**LIBRARY & COMMUNITY CENTER
CITY of UNION GAP**

BORArchitecture, pllc.
1320 North 16th Avenue, Suite C
Yakima, Washington 98902
(509) 454-3299

NOTICE TO BIDDERS:

SHEET A001 – SITE PLAN

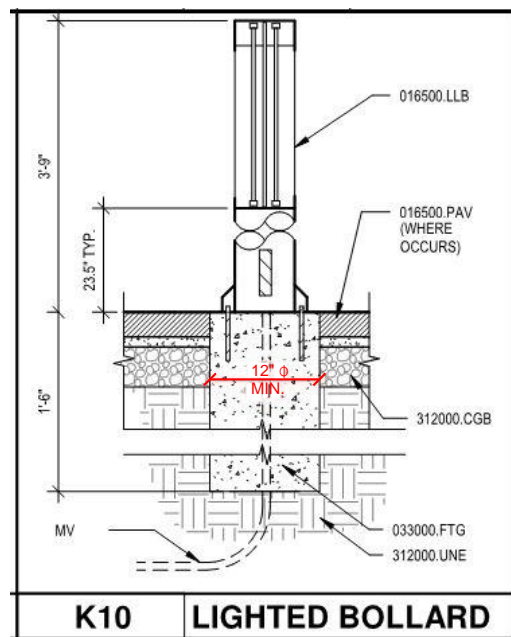
- A. Keynote Legend; **Delete** Keynote 260010.RTL.

- B. Keynote Legend; **Delete** Keynote 260010.RUB.

- C. A1 – SITE PLAN; **Delete** the line — — T — — and boxes indicating the relocated telephone circuits and in-ground boxes.

- D. A1 – SITE PLAN; **Revise** the detail reference for key note 260010.LLB, near the southwest corner of the building outline, to read SEE K10/A021 in lieu of **SEE K10/A002**.
